Case # 16-05

SUBJECT: Proposed New Dual Curb Ramp Details and Revisions to Section 340

Purpose: Incorporate new standard details for dual curb ramps (radial and directional) meeting latest ADA requirements and revisions to Section 340 for maximum grade allowances and measurement. The intention is for construction details to have the “build to” slopes/grades that will allow for tolerance while the specification provides the maximum limits for acceptance.

DETAIL NO.
236-3

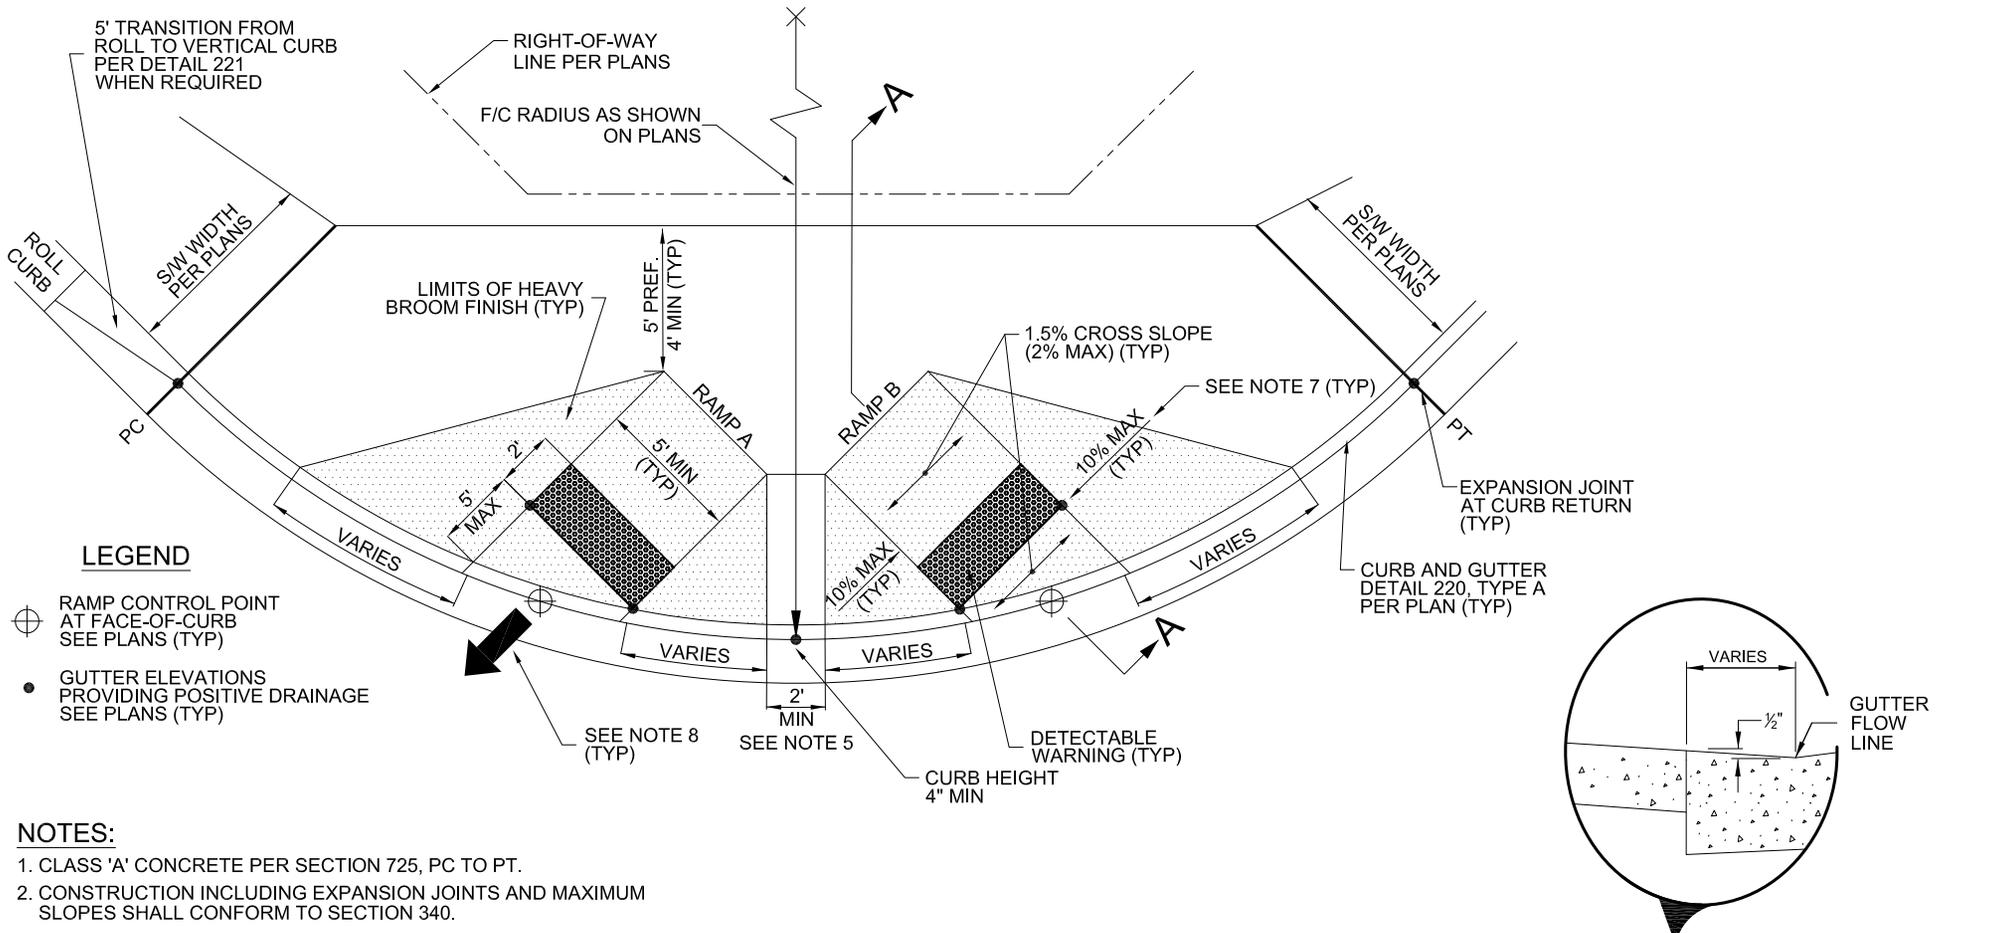
- Revised all details removing table with ramp and wing lengths since lengths will vary depending on curb height and other factors. More flexibility and in-line with many current jurisdiction details.
- Revised both 20’ radius details (236-3 and 237-3), moving expansion joint beyond PC/PT and options for curb transition requirements.
- Removed the “ROUGH” from the broom finish callout on all details.
- Added note on 236-1 and 236-2 for the minimum 4’x 4’ turning space to keep within crosswalk.
- No changes to Section 340.3.9 Tolerances from previous package.
- Minor change to Section 340.5 Measurement from previous package.
